CITY OF ALBUQUERQUE

RE: Carmel Ridge Subdivision
Grading and Drainage Plan
Engineer's Stamp Date 12-16-2016 (File: C20D075)

CARMEL RIDGE SUBDIVISION

BEING A REPLAT OF LOT 29, BLOCK 3, UNIT 3, TRACT 2, NAA  
GRADING & DRAINAGE PLAN

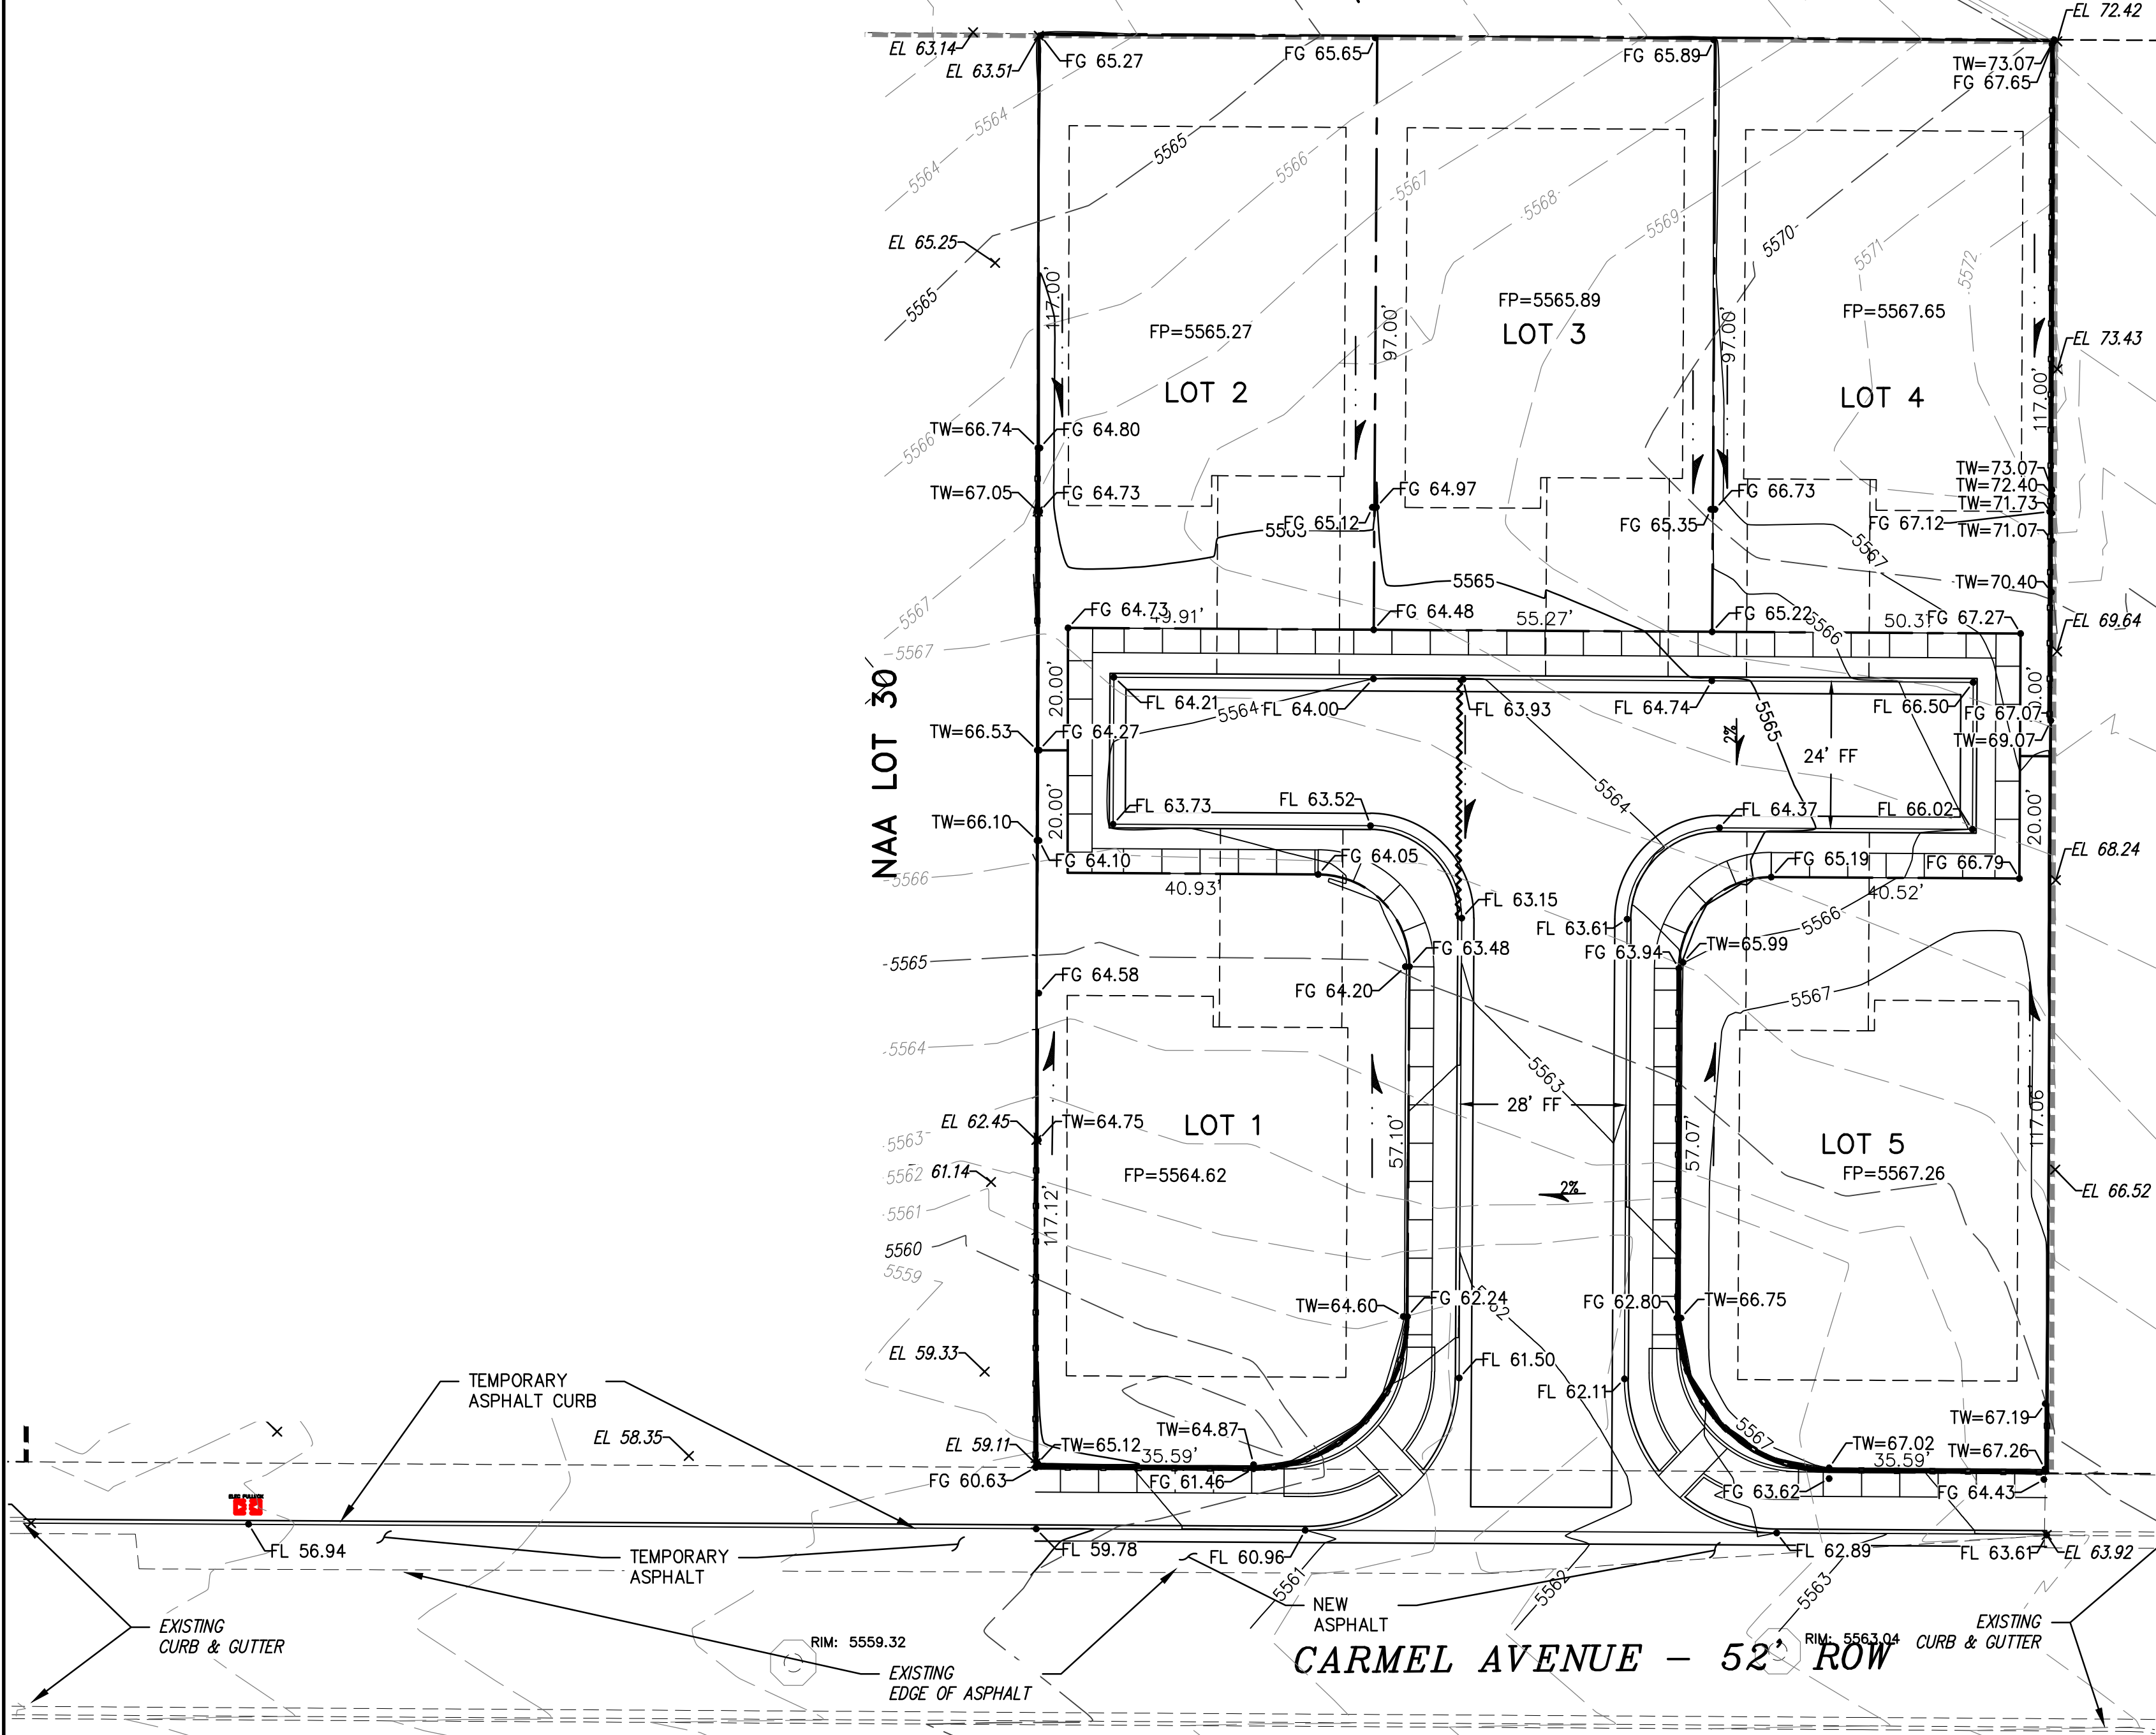
1. Provide a retaining wall on the north of lot 3 and lot 4, where difference between existing and proposed grades is 2 feet or greater.
2. Provide FG grades in the south east area of lot 4. There are TW grades, but no BW/FG grades
3. Please check the grade elevation between the flow line and back of side walk, as it seems to not meet the city standard; curb height plus 2% from top of curb to back of sidewalk.
